**STATE SIGNIFICANT DEVELOPMENT
ASSESSMENT REPORT:
*Faculty of Arts and Social Sciences
Building, The University of Sydney
(SSD 7081)***

Environmental Assessment Report
Section 89H of the *Environmental Planning and
Assessment Act 1979*

December 2016

Figure 14: Southern (Internal) elevation – plant height non-compliance (source: Applicant)

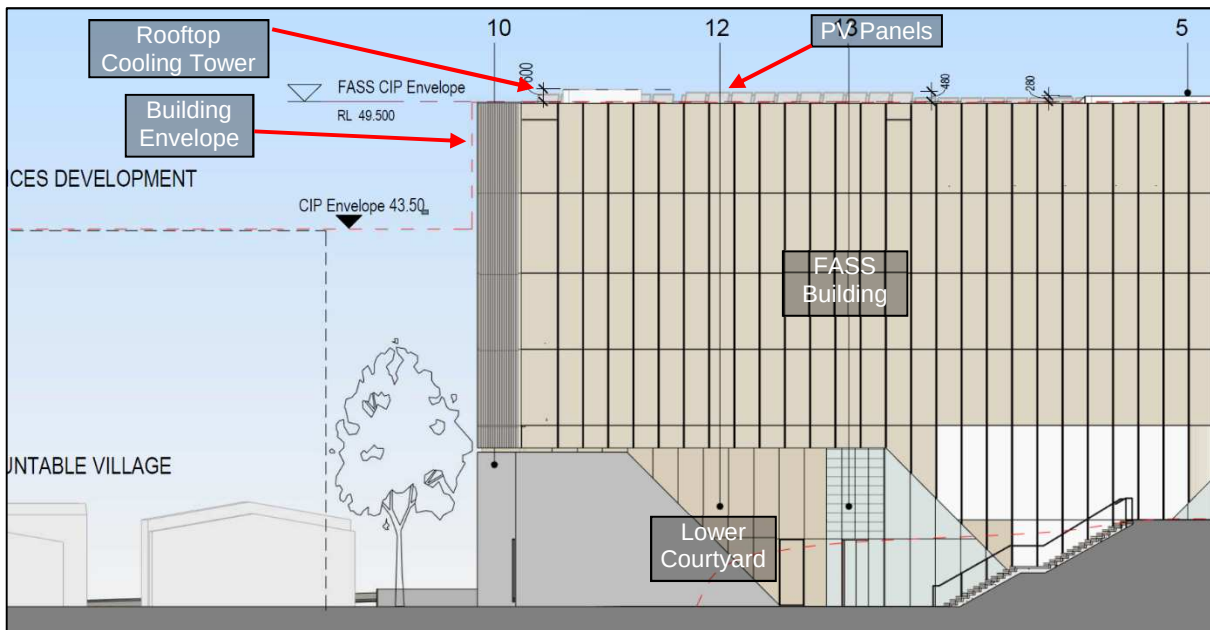
The proposal seeks approval for a new six storey FASS building, with a maximum building height 23.85 metres (RL 49.5) to the top of building parapet or 24.45 metres (RL 50.1) to the top of cooling tower (600 mm above the approved building envelope height of RL 49.5), and a maximum GFA of 7,118 sqm. Rooftop solar photovoltaic (PV) panels and a skylight are also proposed on the roof of the FASS building, which will project slightly above the envelope.

- the resultant height exceedance from additional PV panels being provided was in response to Council's request to increase the size of the system;

- integration of the RD Watt building into the proposal has fixed the level of the ground plane between both buildings and the associated level of the FASS building, meaning the FASS building cannot be readily lowered into the ground to reduce its apparent height; and
- the use of a cooling tower has both environmental (i.e. energy use) and amenity (i.e. noise) benefits over plant designs that may fully comply with the approved building envelope height.

Figure 18: Proposed upper courtyard landscape design section (source: Applicant)

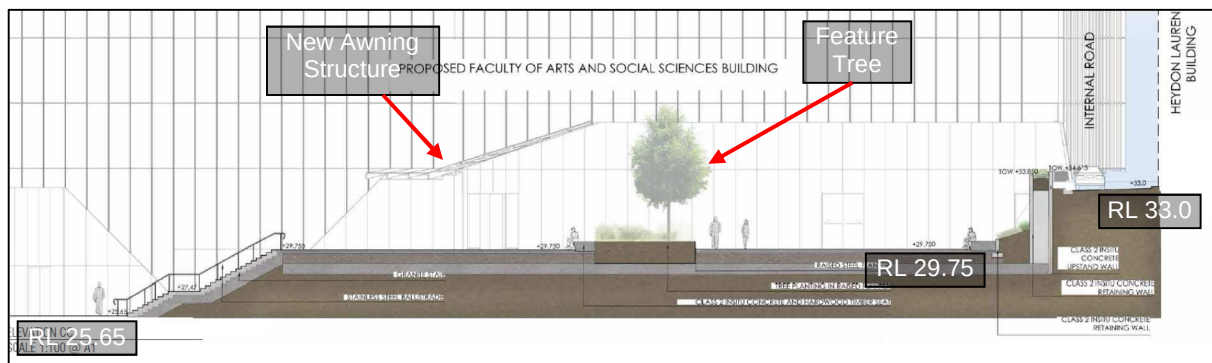
- a design change from a glass to solid façade of the lecture theatre creates the opportunity for public art to be integrated; and
- Science Road provides the principle pedestrian connections within the locality and the significant level changes between the development site and adjacent Heydon-Laurence building and its associated heavily utilised service lane do not adequately justify an internal connection between the sites being provided (see **Figure 18**).

The Department acknowledges the applicant's position that the building separation distance and size of the courtyard is larger than that envisaged under the approved CIP and considers satisfactory amenity levels can be achieved for the designed functionality of the space. In this regard, the primary function of the upper courtyard is to provide unobstructed pedestrian circulation between the FASS building and RD Watt building. Further, the lower courtyard would have satisfactory amenity levels to ensure the reasonable comfort of its occupants. The Department agrees that the arrangement of the courtyard space between the two buildings has been refined and improved in this application.

Figure 20: New awning structure upper courtyard 3D model renders (source: Applicant)

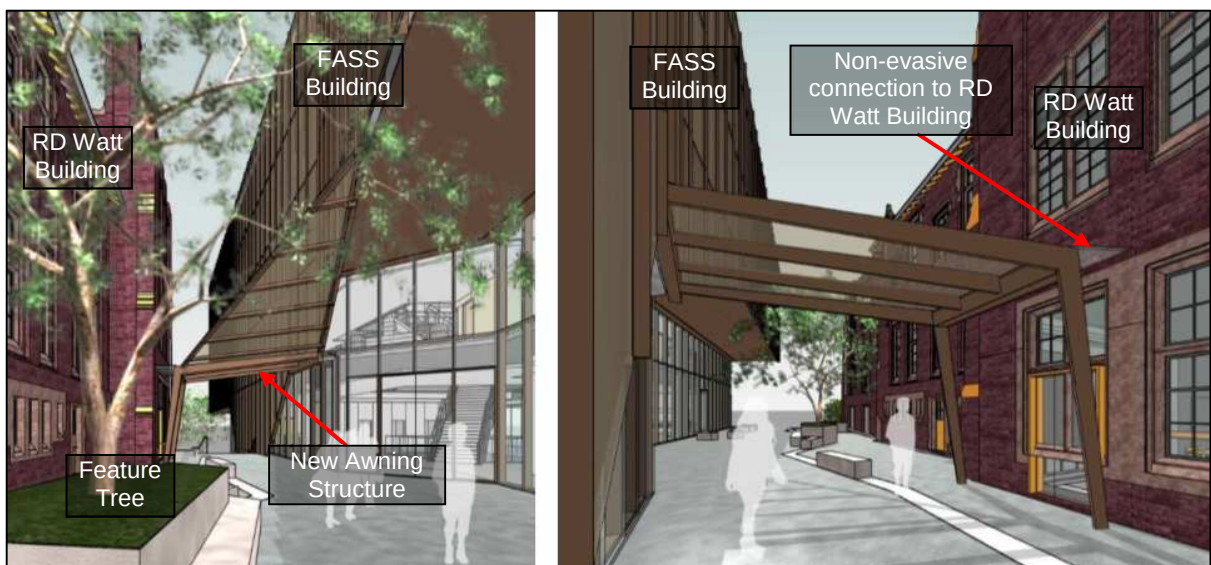
- further detail should be provided on the proposed awning between the FASS building and the existing RD Watt building to ensure that visual and physical impacts on the heritage listed RD Watt building are minimised;

The Department has considered the submissions received, the applicant's EIS and its RtS response to those submissions, and is satisfied that the proposal has been designed to minimise any potential impacts on the heritage significance of the RD Watt building and nearby heritage items. The proposed new awning design satisfies the recommendations of the applicant's HIS and proposes minimal intervention to the northern façade of the RD Watt building, while providing a contemporary link to the proposed FASS building. The OGA has also accepted the revised awning design.

Figure 21: Proposed bicycle parking location (source: Applicant)

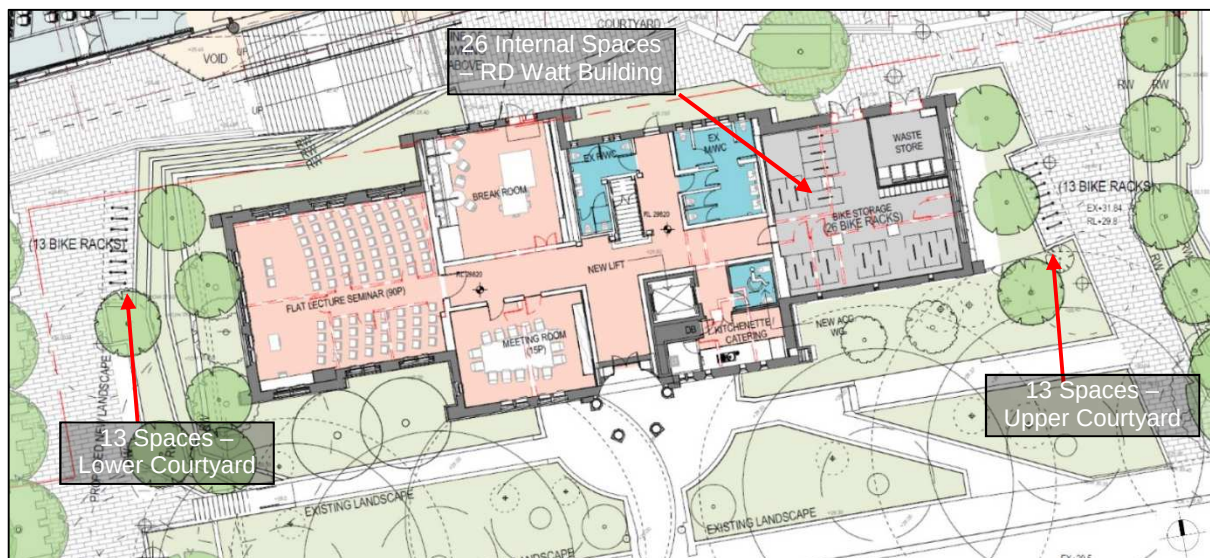
Council recommended that the number of bicycle parking spaces and end-of-trip facilities proposed to be provided be increased to comply with its DCP, being a minimum 111 bicycle parking spaces (26 staff and 85 student spaces), 13 showers and 111 lockers. It also recommended a green travel plan be prepared to encourage a sustainable transport modal shift.

The Department notes that future applications under the approved CIP are required to provide bicycle parking and end-of-trip facilities in accordance Council's relevant controls. The applicant had also committed to providing these new facilities in conjunction with the staged delivery of development under the CIP as a component of each new building to satisfy the University's projected staff and student population growth, estimated at 10,000 additional students and staff by 2020. Under the approved CIP, the University had also proposed that bicycle parking be calculated based on the expected peak staff and student occupancy of 50 per cent, generating a requirement of approximately 2,900 bicycle parking spaces by 2020.

The Department has therefore concluded that a condition be imposed requiring the draft STAMP be updated, and prepared by a suitably qualified transport planner in consultation with Council, that outlines where, and quantifies how and when, future bicycle parking and end-of-trip facilities will be provided to meet the existing campus deficiencies and projected future demand. It is also concluded that a condition be imposed requiring the applicant provide bicycle parking and end-of-trip facilities in accordance with the amount recommended by Council, unless it can be demonstrated to the satisfaction of the Secretary in the updated draft STAMP that a lesser amount would satisfactorily address the established and projected demand.
